Product Change Notification

PCN-MI-998-2017

Business Unit	Product Line Code	Type of Change	Action	Date of Issue
MI - Marking and Installation	BG2	Product Change Notification	Notify Distributors and Field	10/27/2017

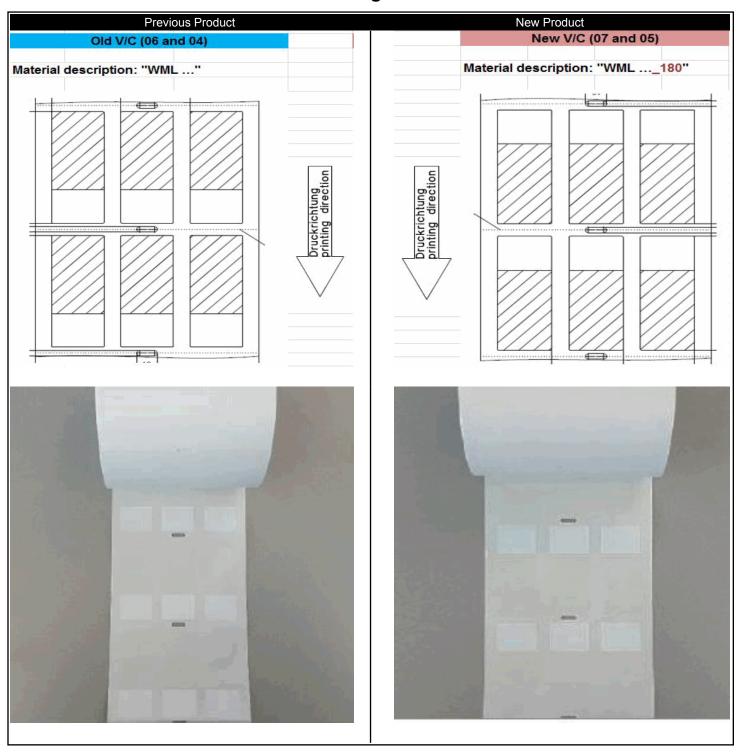
IMPORTANT: To use this new format of labels, you must select the correct material file within Clip Project. You must be using Clip Project marking 8.7 and choose WML..._180 (see screen shot below).
